Access Compliance Report

Public Rights-of-Way

(Curb Ramps)

Intersection ID: 11170	Main Street: E_22ND_ST	Cross Street: N_DAVIDSON_ST	Location: W
ADA ID: FA3733174F15	Ramp Type: BlendTrans1	Initial Pass/Fail: Fail	Overall Compliance: No
		Severity Score: 8.75

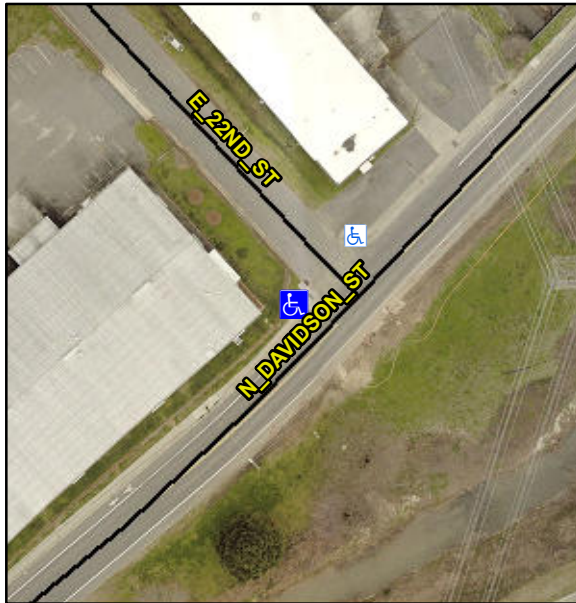
Not Found, R304.5.1

Compliance	Description	Data	Compliance	Description	Data
N/A	Ramp Length (in)	29.5	Yes	BlendTrans Slope (%)	4.9
No	Ramp Width (in)	41.0	Yes	BlendTrans XSlope (%)	0.9
N/A	Flare Type LT	N/A	N/A	Flare Type RT	N/A
N/A	Flare Slope LT (%)	N/A	N/A	Flare Slope RT (%)	N/A
N/A	Flare Traversable LT?	N/A	N/A	Flare Traversable RT?	N/A
N/A	Landing Length (in)	N/A	N/A	DWS Provided?	N/A
N/A	Landing Width (in)	N/A	N/A	DWS Contrast?	N/A
N/A	Landing Slope (%)	N/A	N/A	DWS Length (in)	N/A
N/A	Landing X Slope (%)	N/A	N/A	DWS Full Width?	N/A
N/A	Landing Curb? (Y/N)	N/A	N/A	DWS Offset (in)	N/A
N/A	Shared Landing?	N/A			
N/A	Gutter Ponding?	Yes	N/A	Gutter Slope (%)	N/A
N/A	Gutter Lip Ht (in)	N/A	N/A	Gutter X Slope (%)	N/A
N/A	Painted X Walk1?	No	N/A	Painted X Walk2?	N/A
	X Walk 1 Direction	To NE		X Walk 2 Direction	N/A
	X Walk 1 Width (in)	N/A		X Walk 2 Width (in)	N/A
	X Walk 1 Slope (%)	0.8		X Walk 2 Slope (%)	N/A
	X Walk 1 X Slope (%)	0.5		X Walk 2 X Slope (%)	N/A

N/A	Ramp inside XWalk1?	N/A	N/A	Ramp inside XWalk2?	N/A
	Road Slope (%)	0.5		Clear Space?	N/A
	Road X Slope (%)	0.8	N/A	Clear Space to XWalk (in)	N/A
N/A	Any Obstructions?	N/A	N/A	Storm Grate/Utility Hazard?	N/A
	Obstruction Type			Storm Grate/Utility Type	
		N/A			N/A
			Yes	Surface Condition? (G/P)	Good
			No	Curb Slope (%)	16.4

Remove & Replace Curb Ramp With Two New Directional Ramps or Equivalent.
